To:	Joe Richardson	From:	Drainage Team
------------	----------------	--------------	---------------

Planning App Ref:	PL/2026/00843
Service Ref:	Drainage
Date:	13/07/2026

Detailed Planning application for the erection of 9 no. dwellings including 4 Affordable Homes with associated infrastructure.

Land at Whitlocks, Bishopstone, Wiltshire

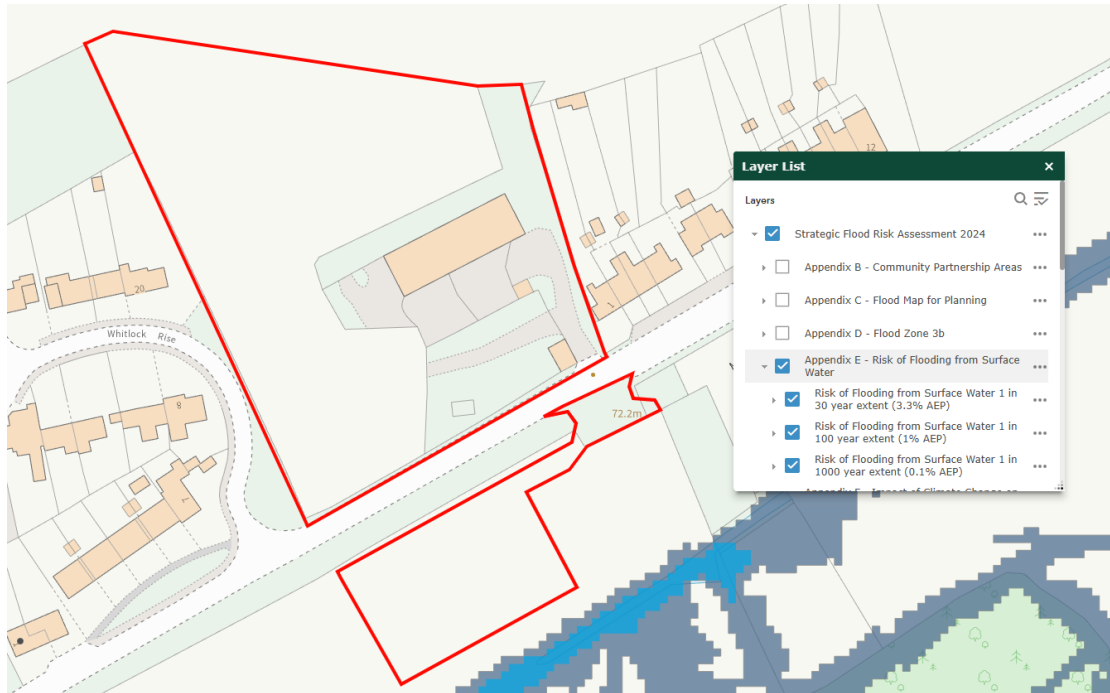
The Wiltshire Council Strategic Flood Risk Assessment, [SFRA Data Explorer](#), has indicated that the site is located within Flood Zone 1 and has a low level of risk from fluvial flooding.

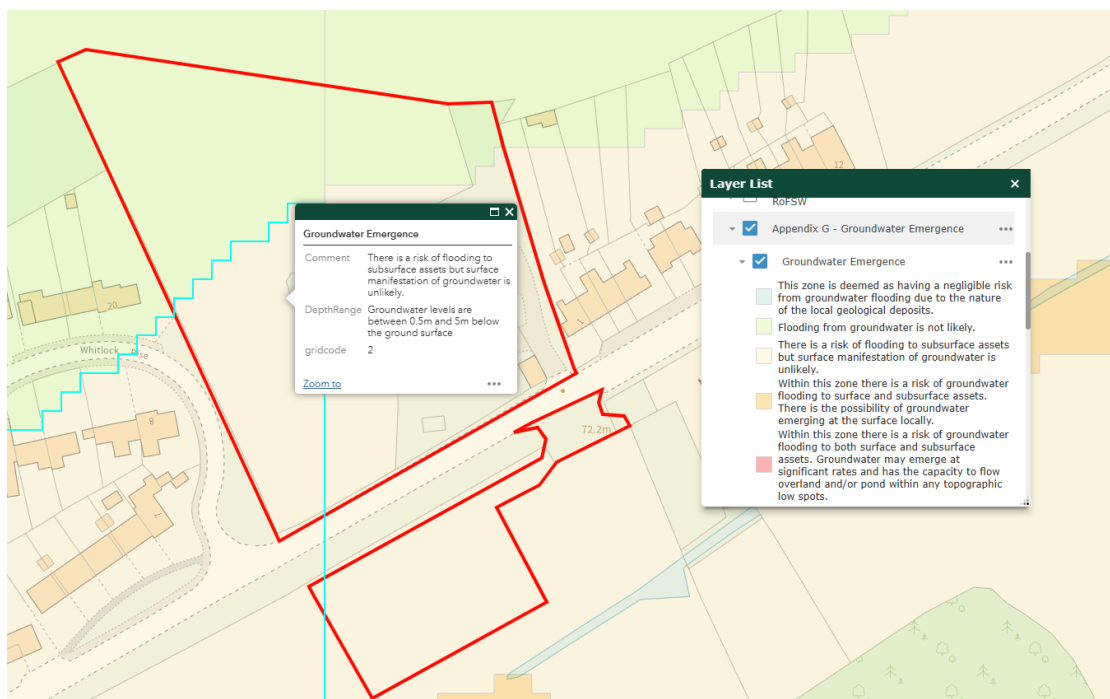
The site has a low level of risk from surface water flooding.
